Certificate of Appropriateness

Property	2933 W. MC KINLEY BL.	Cold Spring Park
Description of work	<ol style="list-style-type: none"> 1. Replace main roof with Owens Corning Oakridge shingles in a brown/tan/beige color tone. 2. Selectively repoint house per conditions below 3. Install scalloped fence with gothic post around rear yard in approximately current location. (shadowbox designs are not permitted, per our guidebook, since 1997). The fence must be picket style (maximum 3.5" spacing) or no spacing on the outside of the fence, as shown in image below. Fence must be painted. 	
Date issued	2/3/2020	PTS ID 114911 COA: roof, repointing, fence

Current conditions at property.

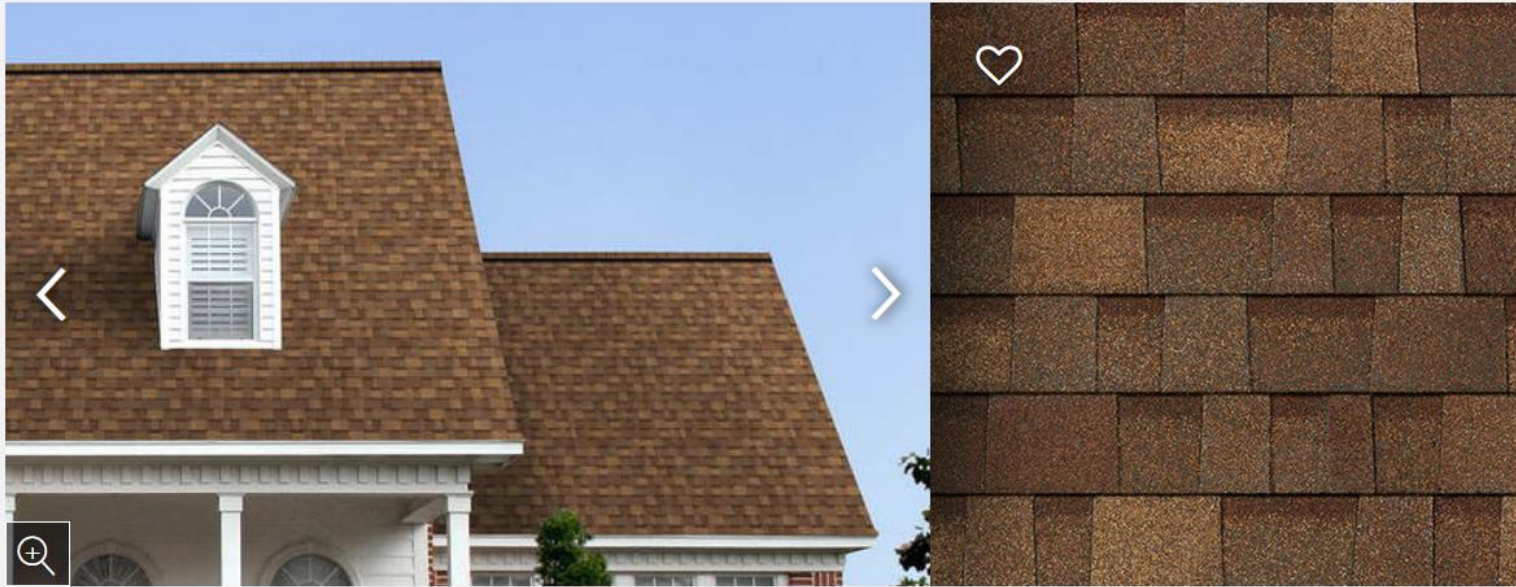
Sample of yard side of fence. Shadow box is not permitted and fence must be painted.

Fence location and height shall comply with zoning requirements. A separate permit is required.

Oakridge® Shingles
Aged Cedar

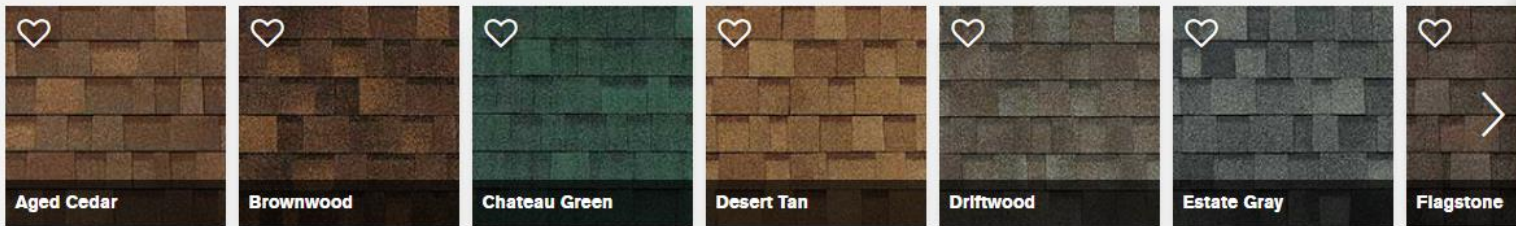
Approved roofing product, use brown/tan/beige or gray color tones.
